**ALERT SERVICE BULLETIN**  
REVISION NOTICE

**SUBJECT: REVISION "A" TO ALERT SERVICE BULLETIN 212-09-134:  
TAIL ROTOR BLADE P/N 212-010-750-ALL, INSPECTION OF.**

NO. 212-09-134  
DATE Nov 09, 2009  
PAGE 1 of 5

**Figure 1**

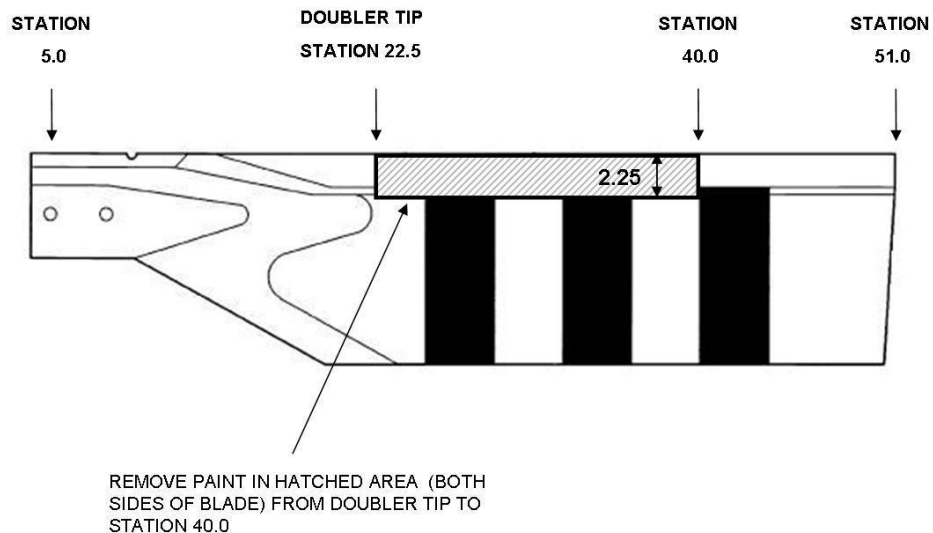
4. Ensure that all paint (on the spar only) is removed from the first 2.25 inches of the leading edge (chordwise) and from the B.S 22.5 (doubler tip) to B.S. 40.0. Refer to Figure 1. This will expose the spar up to the fillet between the blade spar and skin. A fillet filled with adhesive runs spanwise between the blade spar and the skin 2.25 inches aft of the blade leading edge, both inboard and outboard sides. The area to be inspected runs along the edge of the spar fillet and a half inch forward of this point. (Between 1.75 and 2.25 inch from the leading edge of the blade and from Blade Stations 22.5 to 40.0, both inboard and outboard sides).
